UNITED STATES PATENT AND TRADEMARK OFFICE

10/539,133

Office Action Summary	Application No. 10/539,133	Applicant(s) WADA, KAZUSHI	
	Examiner W. Wendy Kuo	Art Unit 2826

DETAILED ACTION

FIG. 1

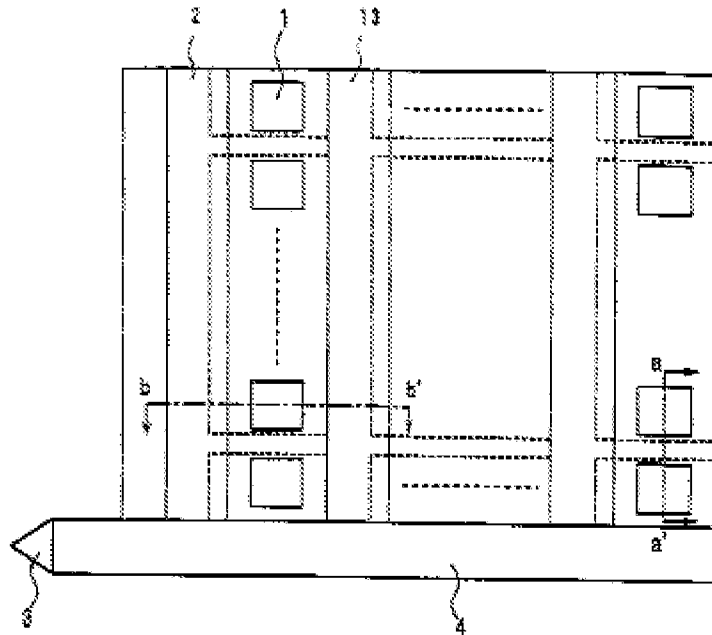
6. **With respect to claim 1**, Inagaki (e.g. Figure 1) teaches a solid state image pickup device comprising:

- a semiconductor region 7 formed on a substrate 5 (Figures 2 and 3);
- a plurality of photo-sensors 1 on the semiconductor region;
- a transfer register 2 extending in the vertical direction and formed in the semiconductor region which transfers (column 6, lines 5-9) signal charges accumulated in said photo-sensors (column 5, lines 49-51); and

- an impurity region 13 (horizontal gridlines between adjacent photodiodes in vertical direction) continuously **formed across substantially the entire region of the semiconductor region from one end of the semiconductor region to an opposite end of the semiconductor region** in a direction orthogonal to the transfer (vertical) direction of said transfer register (column 6, lines 39-52), wherein,

- said impurity region is provided at a position between said photo-sensors 1 adjacent to each other along the transfer direction of said transfer register in the semiconductor region

11. **With respect to claim 7**, Inagaki (e.g. Figure 1) teaches a second barrier layer 13 (vertical gridlines between adjacent photodiodes in horizontal direction) (column 6, lines 39-52) comprised of an impurity region portion formed along said transfer register.

FIG. 2

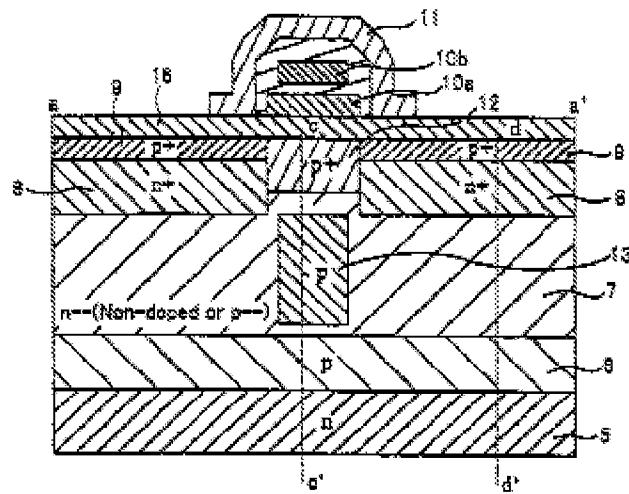
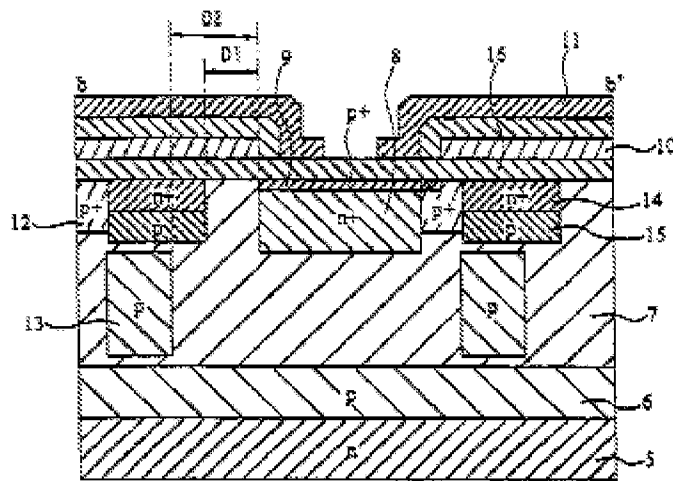
7. **With respect to claim 2**, Inagaki (e.g. Figures 2 and 3) teaches that said impurity region 13 is formed at a position in the semiconductor region deeper than said transfer register (vertical CCD) (column 6, lines 2-4 and lines 39-42).

9. **With respect to claim 4**, Inagaki (e.g. Figure 2) teaches that a channel stop region 12 comprised of an impurity region is formed, separately from said impurity region, between said photo-sensors (photodiodes) adjacent to each other along the transfer (vertical) direction of said transfer register (column 6, lines 34-38) and in the vicinity of the surface of said semiconductor region.

Inagaki (e.g. Figures 2 and 3) further teaches an overflow barrier 6 formed between the semiconductor layer and the substrate.

like pattern (i.e., the grid-like pattern is formed by impurity region 13 at the same depth in both the vertical and horizontal directions (parallel to the substrate) and is not due to the crossing of the impurity region 12 and the impurity region 13) and it is the horizontal gridlines of impurity region 13 that are orthogonal to the transfer direction (column 6, lines 39-52). Because the solid state image pickup device of Inagaki is fabricated in a bottom-up manner by sequentially growing epitaxial layers upon a substrate and doping those layers to form impurity region 13 (second channel stop region) (column 9, lines 10-29), at the depth that impurity region 13 is formed, the horizontal lines of impurity region 13 are continuous. Impurity region 12 is formed above impurity region 13, and thus, does not intersect the horizontal gridlines of impurity region 13 (Figures 2 and 3).

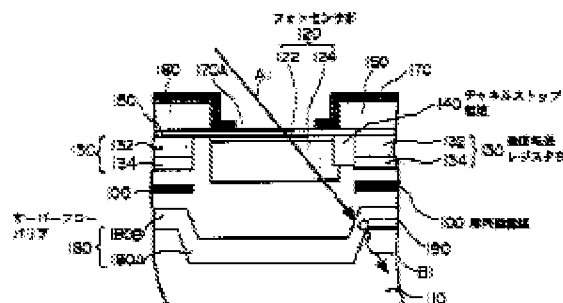
Inagaki fails to teach that the overflow barrier is in a projected and recessed shape at an interface thereof in the direction of said substrate, and a projected portion of said projected and recessed shape is disposed at a position corresponding to a position between said photo-sensors. Komatsu teaches that the overflow barrier is in a projected (shallow) and recessed (deep) shape at an interface thereof in the direction of said substrate, and a projected portion of said projected and recessed shape is disposed at a position corresponding to a position between said photo-sensors (see abstract figure) in order to prevent color mixing and smear by limiting the move of a signal charge between adjacent photosensor sections.

It would have been obvious to one of ordinary skill in the art at the time of the invention to provide the image pickup device of Inagaki with the overflow barrier of Komatsu for the benefit of preventing color mixing and smear by limiting the move of a signal charge between adjacent photosensor sections.
